HISTORIC AND DESIGN REVIEW COMMISSION

January 02, 2019

HDRC CASE NO: 2018-580
ADDRESS: 206 CAMARGO
LEGAL DESCRIPTION: NCB 924 BLK 5 LOT N 134 FT OF 2
ZONING: RM-4, H
CITY COUNCIL DIST.: 1
DISTRICT: Lavaca Historic District
APPLICANT: Michael Taritas
OWNER: Michael Taritas
TYPE OF WORK: Exterior modifications, demolition of rear additions, rehabilitation, fenestration modifications, construction of a rear addition, fencing and driveway installation
APPLICATION RECEIVED: December 18, 2018
60-DAY REVIEW: January 16, 2019
REQUEST:

1912 SANBORN MAP

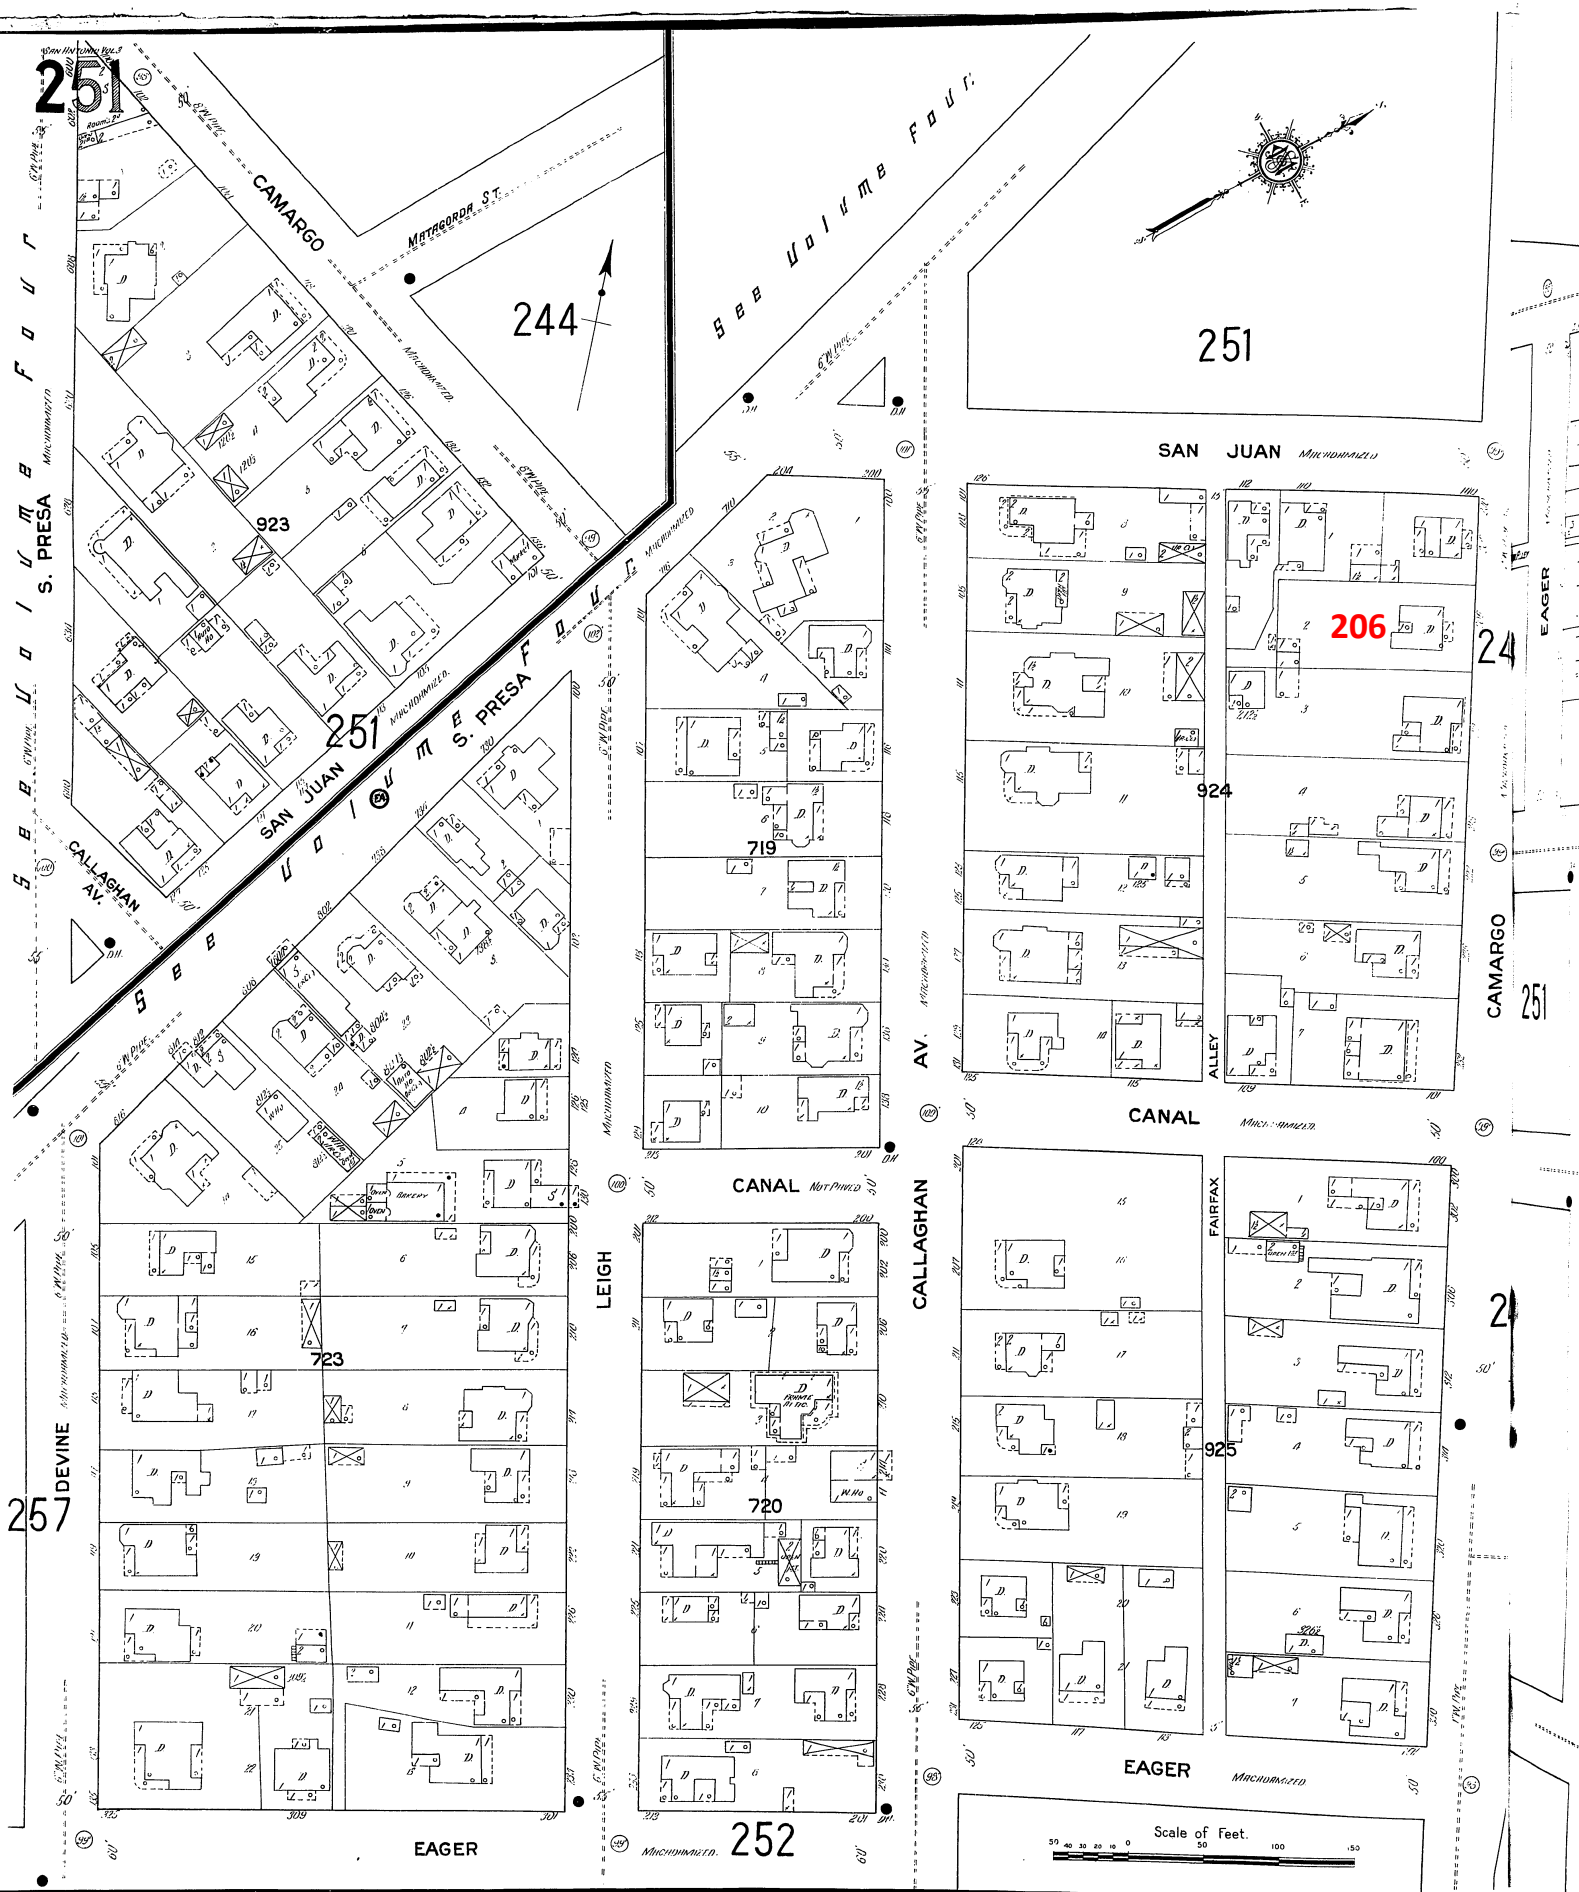
- e. REMOVAL OF ADDITIONS – The applicant has proposed to remove a series of contributing rear additions, including a contributing addition to the rear of the original structure, found on the 1904 Sanborn Map; a contributing addition to the previously noted addition which is found on the 1912 Sanborn Map; and a contributing screened porch addition to the rear of the primary structure rear facing gable which is found on the 1951 Sanborn Map. Staff finds that each of these additions holds historic integrity and does not recommend approval.

1. Staff does not recommend approval of item #1, the demolition of the exiting, contributing rear additions based on finding c. Staff recommends that the demolished contributing additions be reconstructed as they previously existed.

2 West Elevation
1/8"=1'-0"

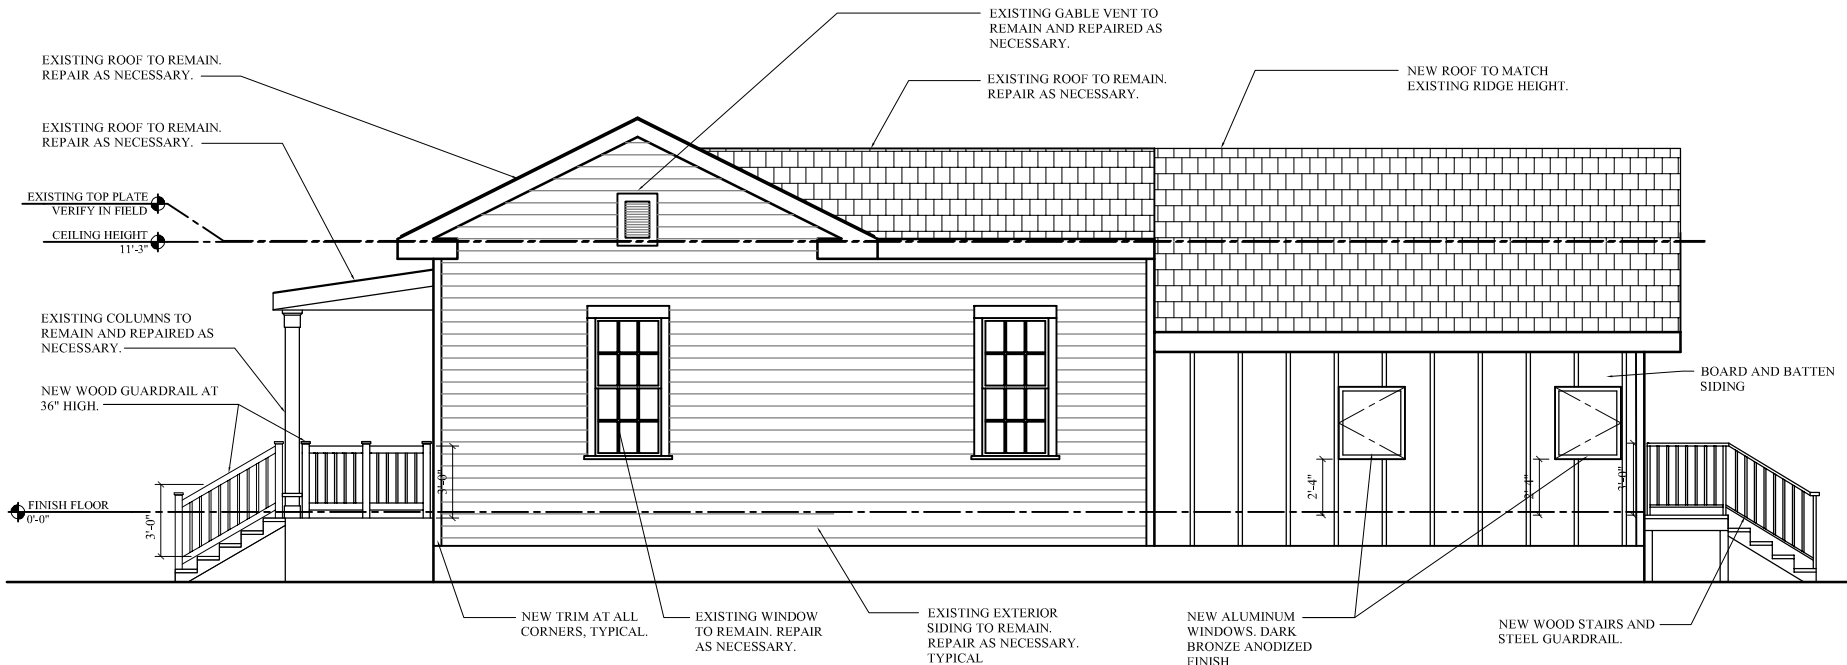
- h. ARCHITECTURAL DETAILS (Addition) – The applicant has proposed a number of architectural details for the proposed addition that are generally consistent with the Guidelines; however, the applicant has proposed picture windows on the west elevation that feature a profile that is not comparable to those of the historic structure. Staff finds that the applicant should incorporate more traditionally sized windows on this elevation that feature sashes. On the rear façade, the applicant has proposed aluminum storefront windows in the living space. Staff finds that the proposed fenestration is not consistent with the Guidelines. Staff finds that an elevation that is consistent with the Guidelines should be proposed.

- i. MATERIALS – The applicant has proposed materials that includes board and batten siding, an asphalt shingle roof and fixed aluminum windows. Staff finds that the proposed board and batten siding should feature boards that are twelve inches wide and battens that are 1 – ½" to 2" wide. Staff finds that wood or aluminum clad wood windows should be installed in the addition.

- j. WINDOW MATERIALS – As noted in finding i, the applicant has proposed to install fixed, aluminum windows. Staff finds that a double-hung, one-over-one wood windows or aluminum-clad wood windows be used. Meeting rails must be no taller than 1.25" and stiles no wider than 2.25". White manufacturer's color is not allowed, and color selection must be presented to staff. There should be a minimum of two inches in depth between the front face of the window trim and the front face of the top window sash. This must be accomplished by recessing the window sufficiently within the opening or with the installation of additional window trim to add thickness. Window trim must feature traditional dimensions and architecturally appropriate sill detail. Window track components must be painted to match the window trim or concealed by a wood window screen set within the opening.

- i. That all windows feature a profile that matches those of the historic structure and feature sashes.
 - ii. That a double-hung, one-over-one wood windows or aluminum-clad wood windows be used. Meeting rails must be no taller than 1.25” and stiles no wider than 2.25”. White manufacturer’s color is not allowed, and color selection must be presented to staff. There should be a minimum of two inches in depth between the front face of the window trim and the front face of the top window sash. This must be accomplished by recessing the window sufficiently within the opening or with the installation of additional window trim to add thickness. Window trim must feature traditional dimensions and architecturally appropriate sill detail. Window track components must be painted to match the window trim or concealed by a wood window screen set within the opening.

- iii. That the addition’s proposed rear façade feature fenestration patterns that are complementary of the historic structure and feature window proportions and materials that are consistent with the Guidelines, as noted in findings h and j.
